# Access Compliance Report Public Rights-of-Way (Curb Ramps)

Intersection ID: 54422	Main Street: LISMORE_LN	Cross Street: KILKENNY_DR	Location: N
ADA ID: 69079BFCD240	Ramp Type: Perp	Initial Pass/Fail: Pass	Overall Compliance: No Severity Score: 20
Codes/Mitigation Info/Possible Solution		Field Measurements/Component Compliance

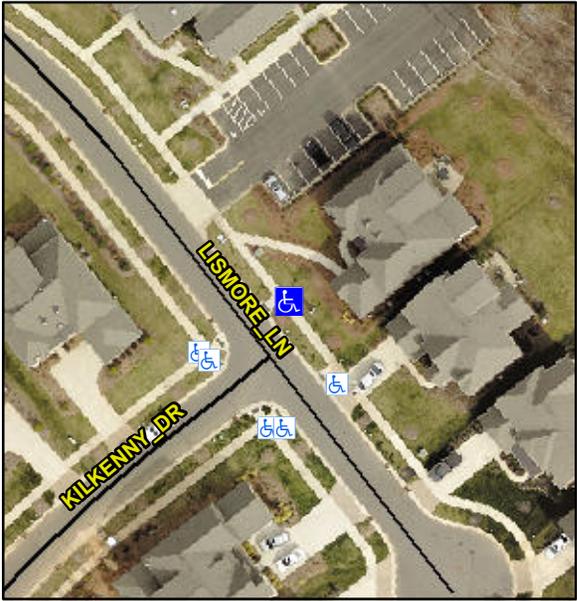
PROW/ADA:  
**R302.7.2, R304.5.4**

Possible Solutions:  
**Remove & Replace Gutter.**
